# ***Value Engineering Study Report***

## ***SR 8/US 78 at Mann Road/Mason Creek Road and at Post Road Intersection Improvements, Douglas County CSSFT-0008-00(375), PI No. 0008375***

***February 2012***

Subject: Final Value Engineering Study Report  
***SR 8/US 78 at Mann Road/Mason Creek Road and at Post Road  
Intersection Improvements, Douglas County, CSSFT-0008-00(375)  
PI No. 0008375***

# VE ALTERNATIVE ROW-1

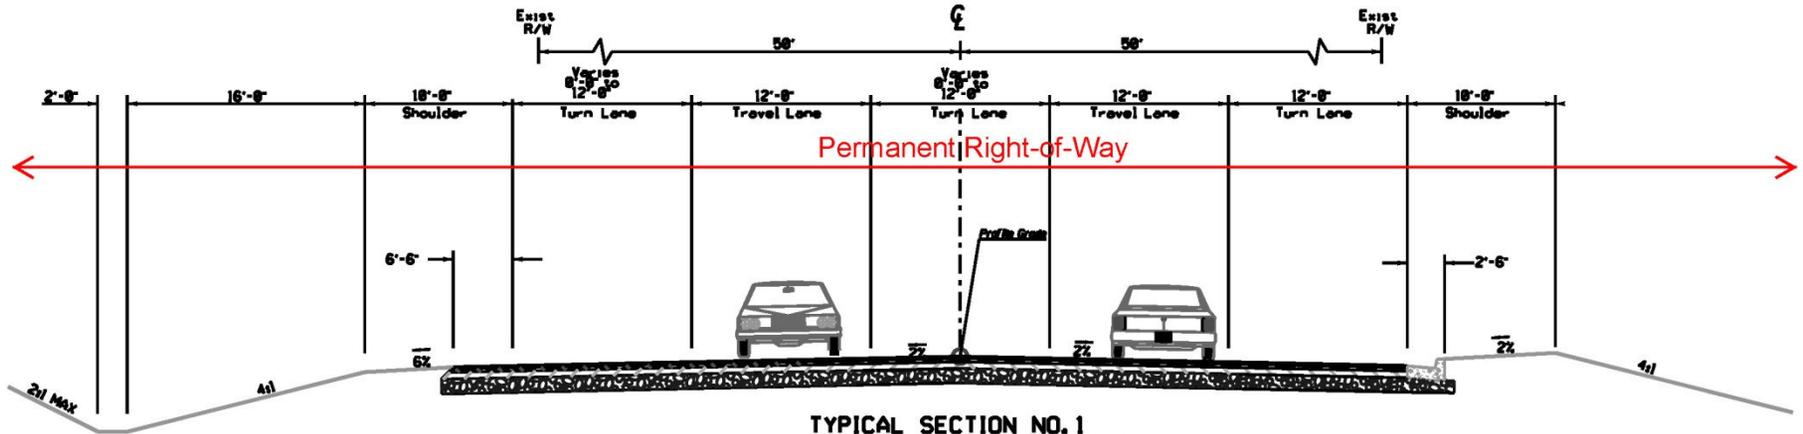
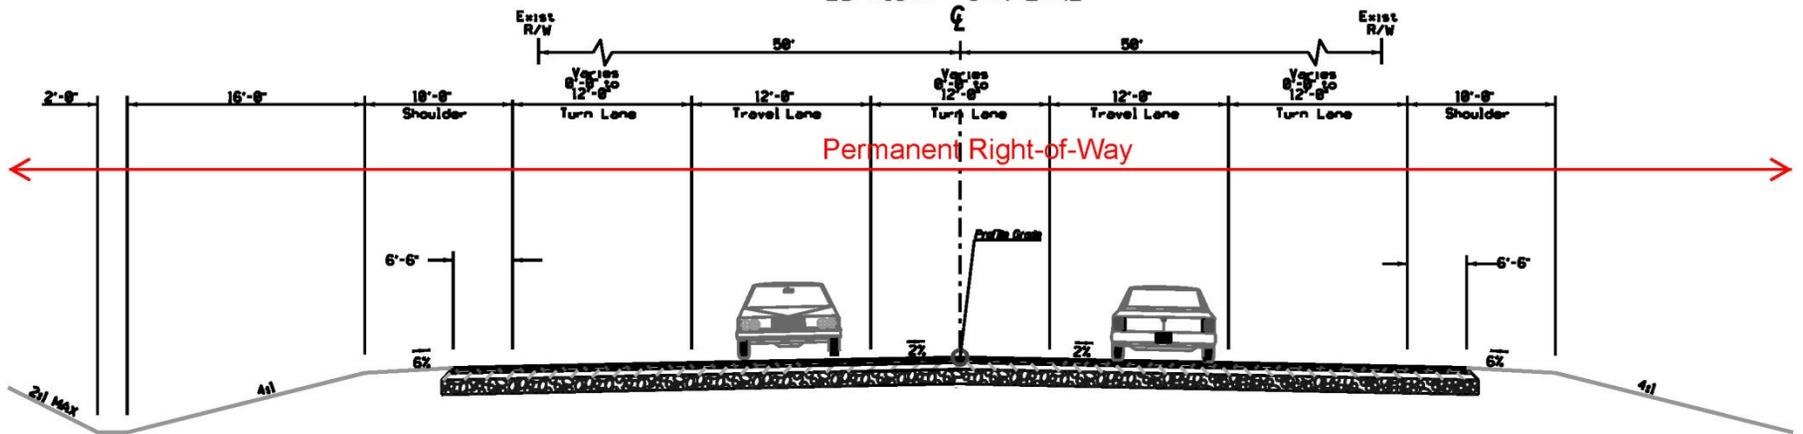
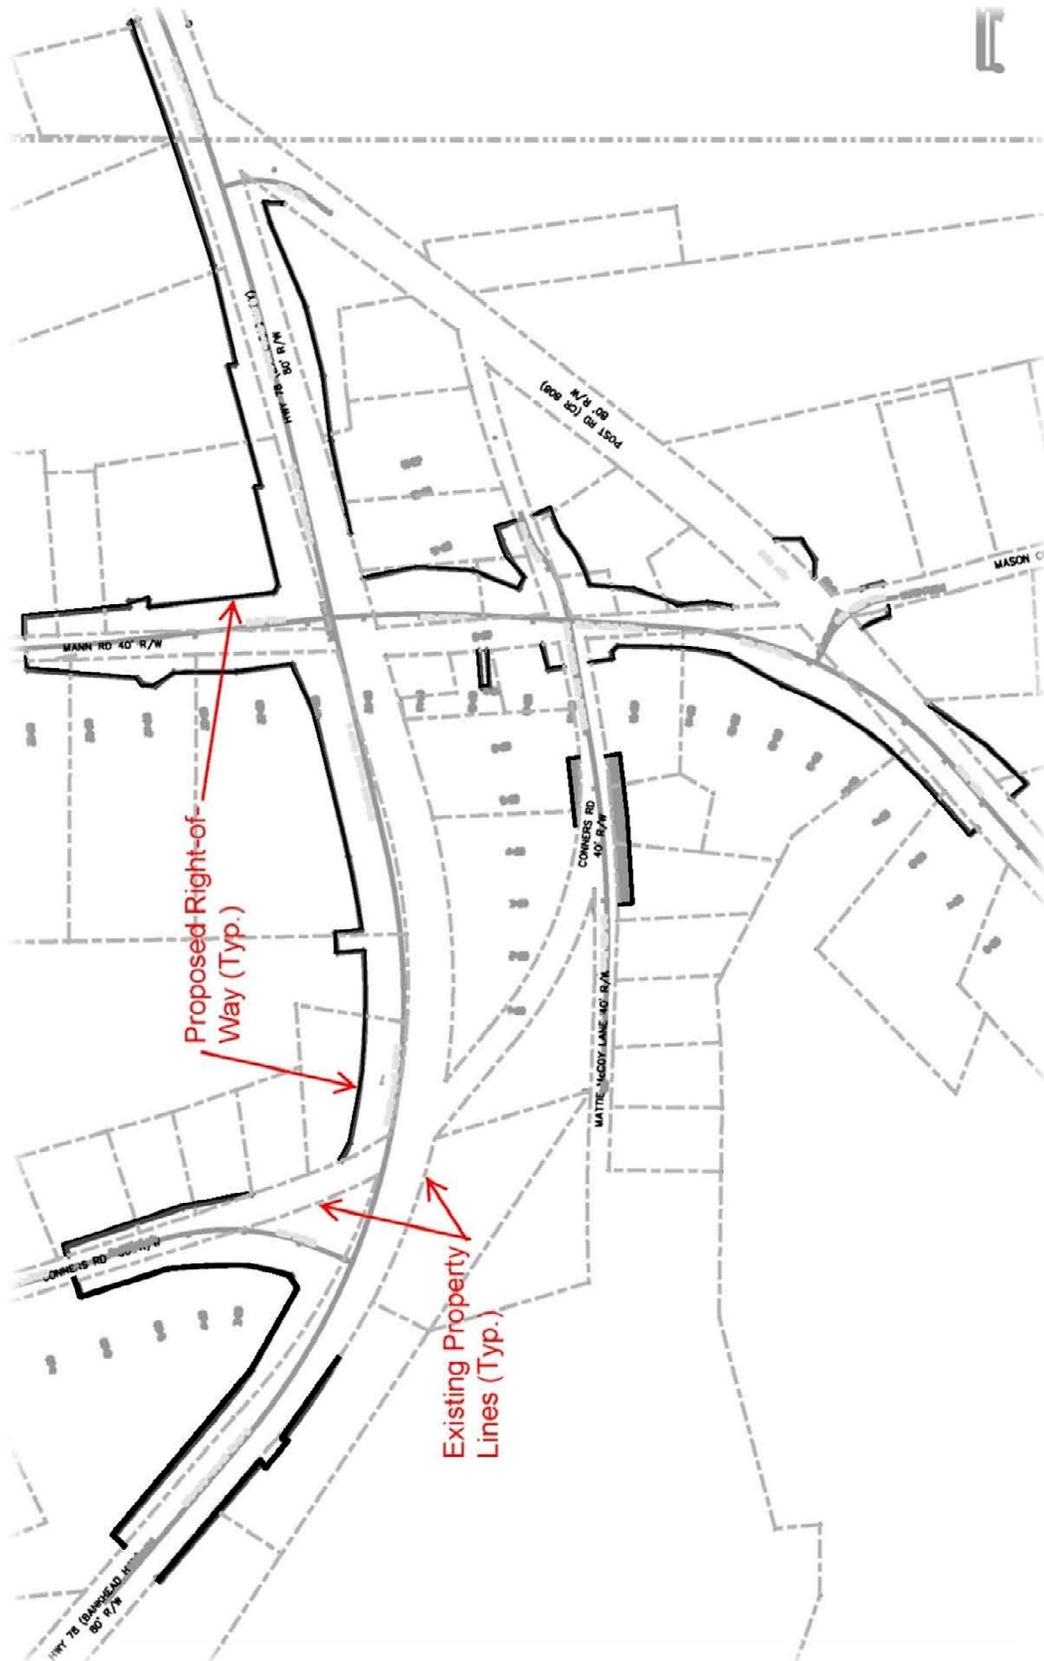
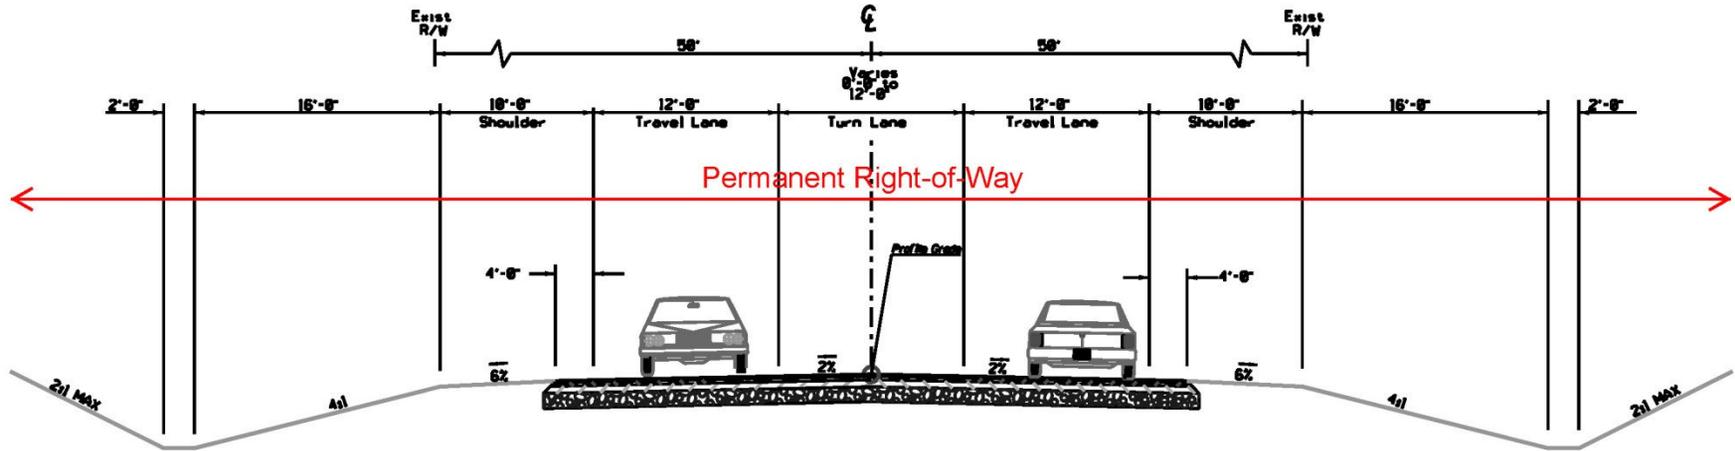
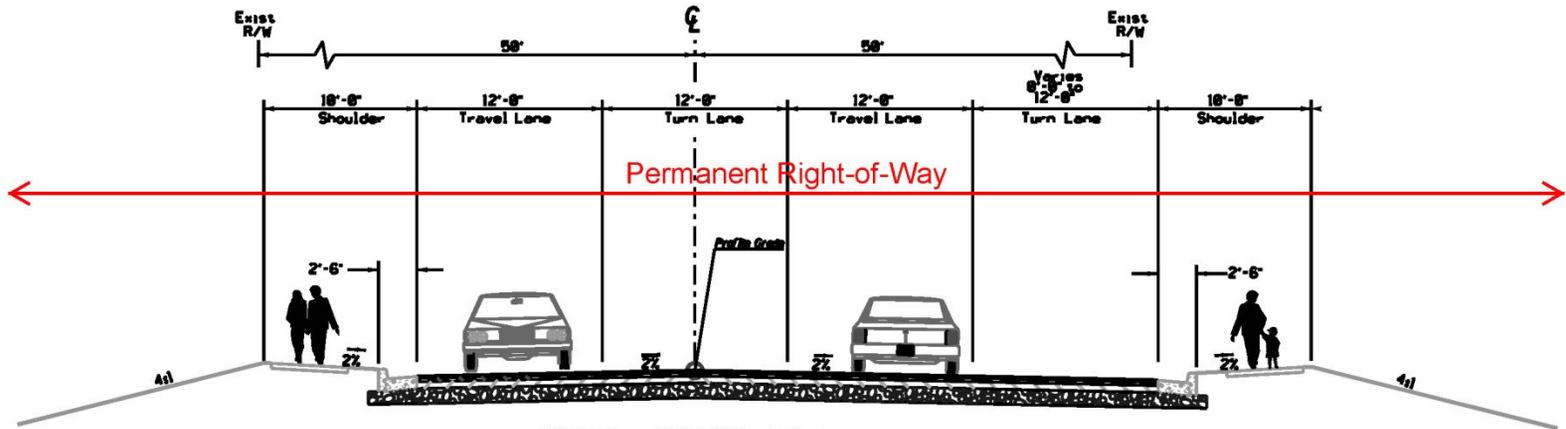
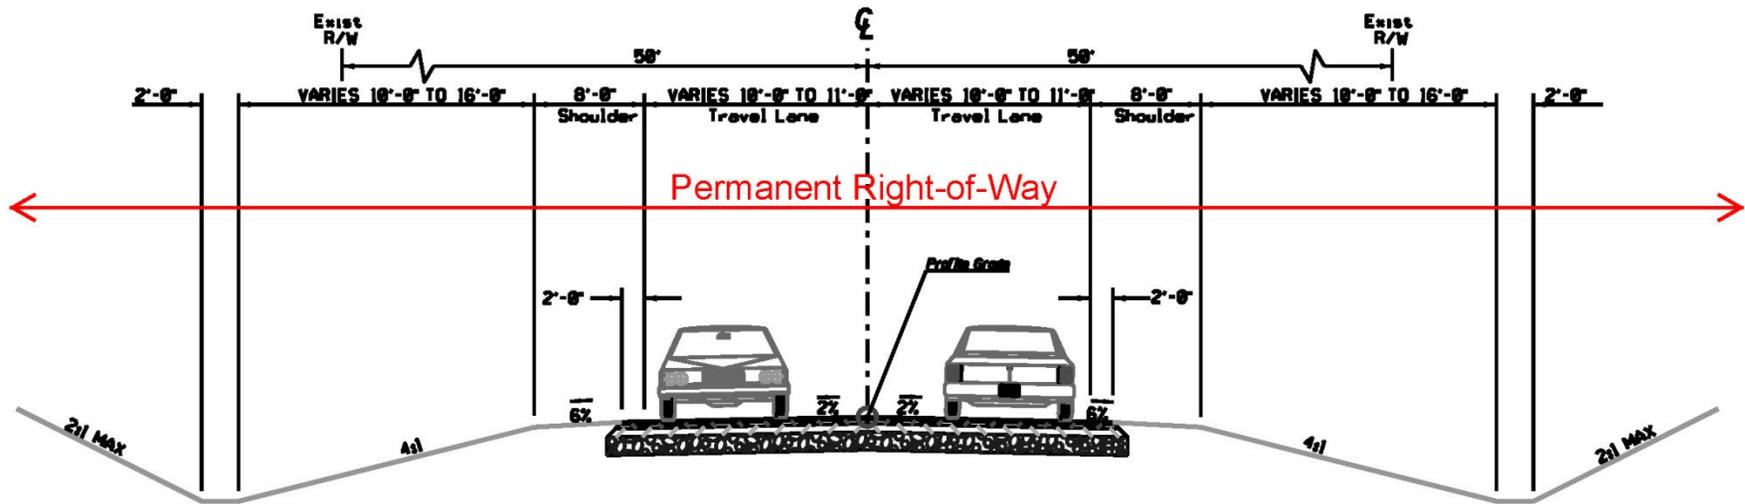
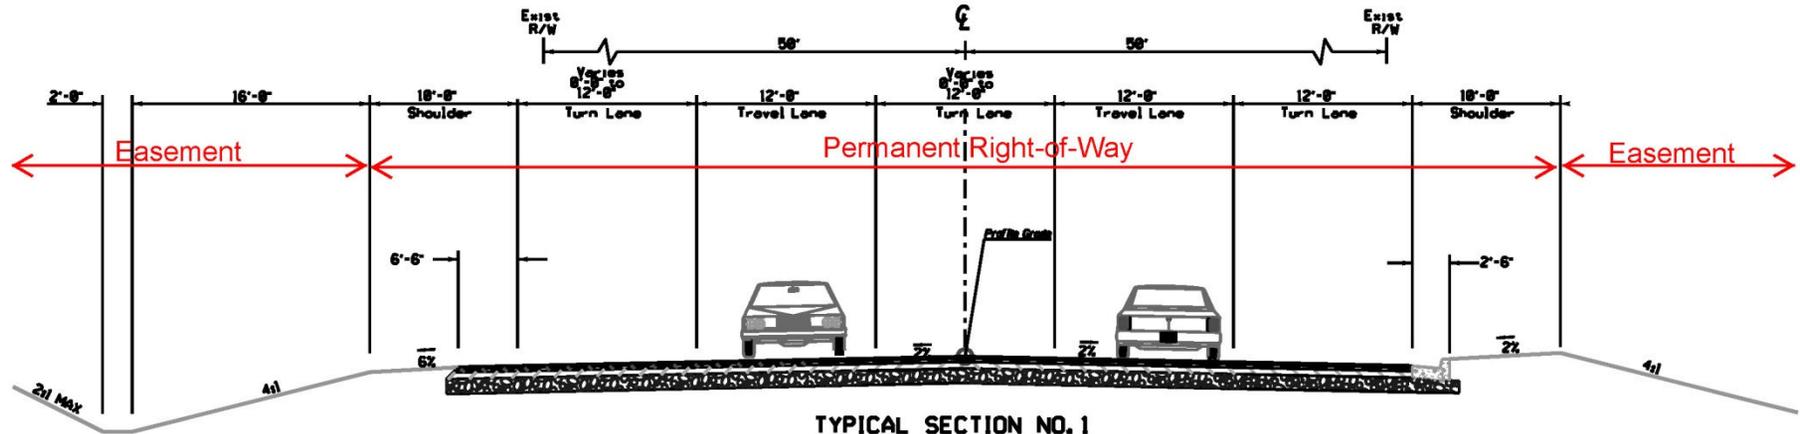
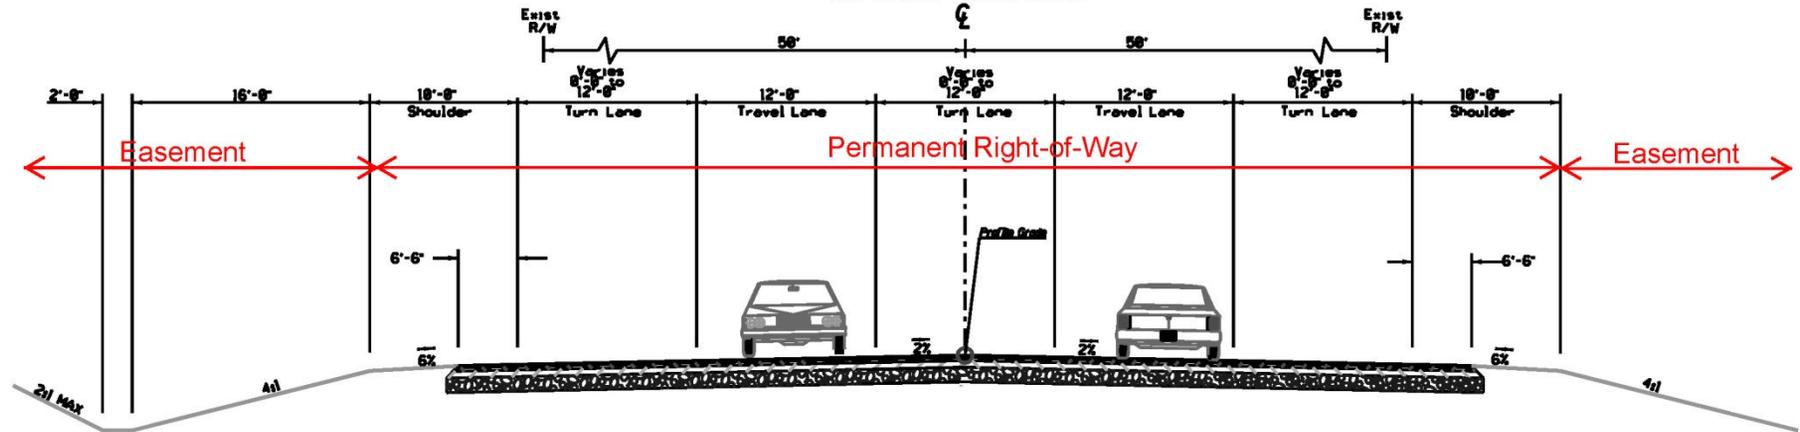
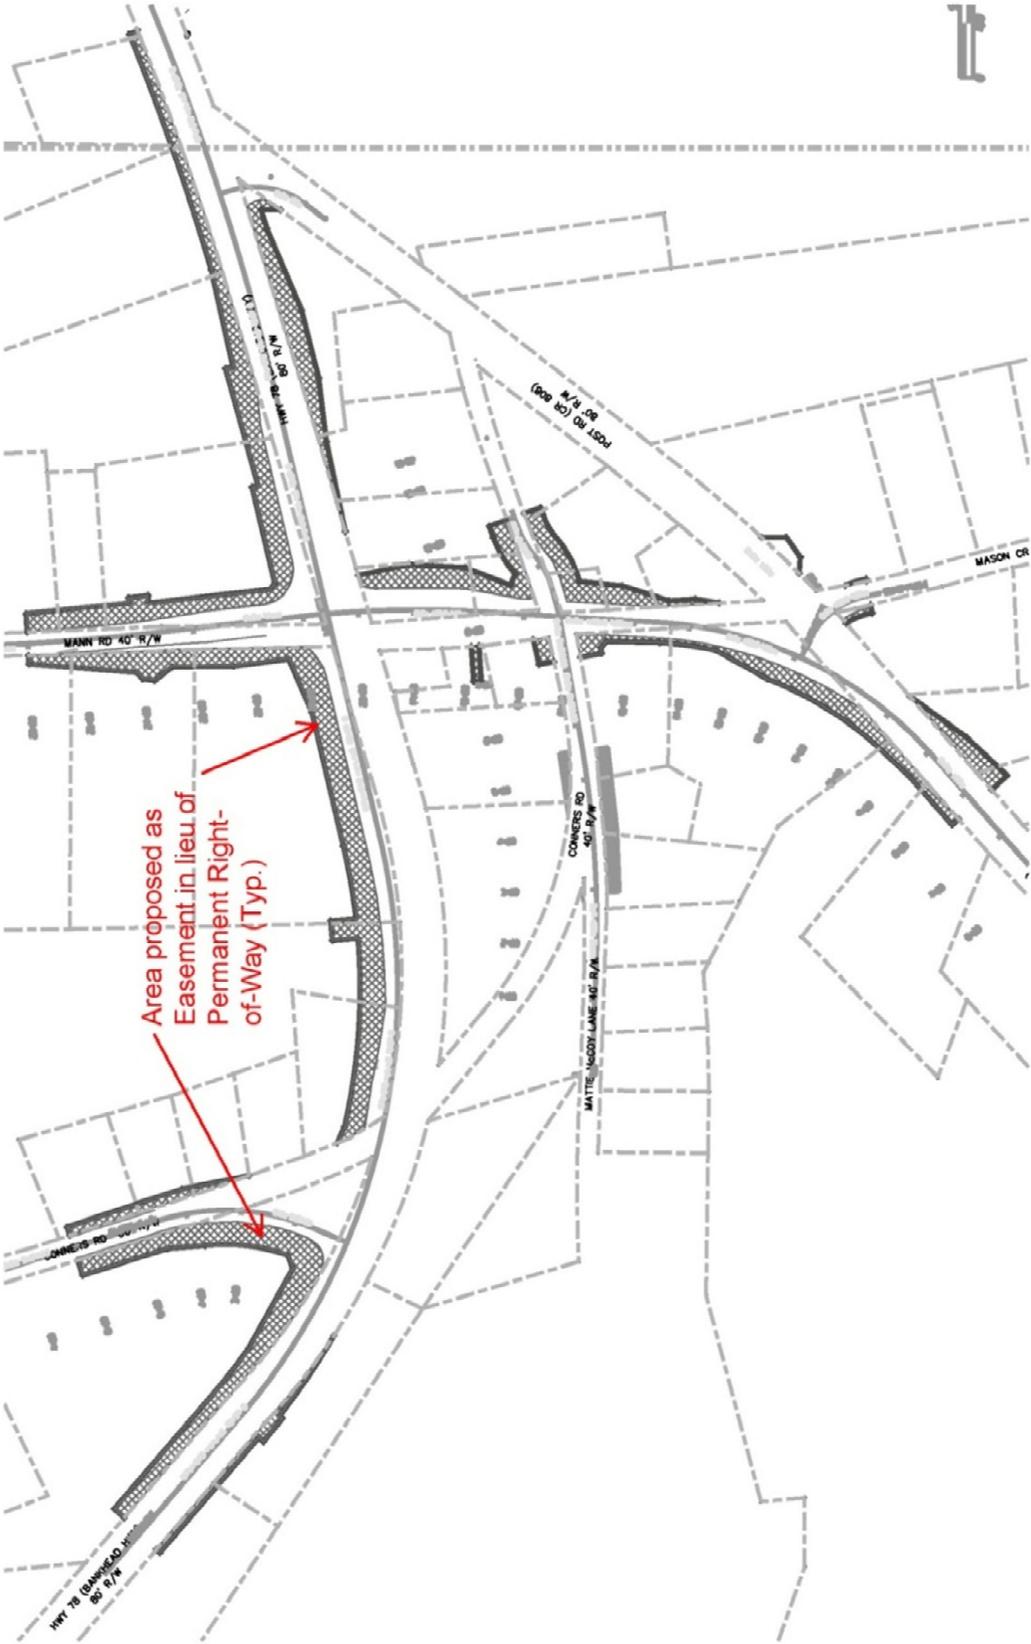
GDOT has accepted the use of easements on a number of recent projects as an effective way to control the overall cost of right-of-way. Full right-of-way purchase may be prudent at specific locations due to maintenance access issues, but oftentimes easements provide the equivalent function at approximately 60% of the cost of a full right-of-way purchase.

**Discussion:** The need and purpose of the project is to reduce crashes and provide improved operations at the area intersections. This can be accomplished with slopes and ditches included in easements instead of required right-of-way.

Use more slope easements in lieu of permanent right-of-way
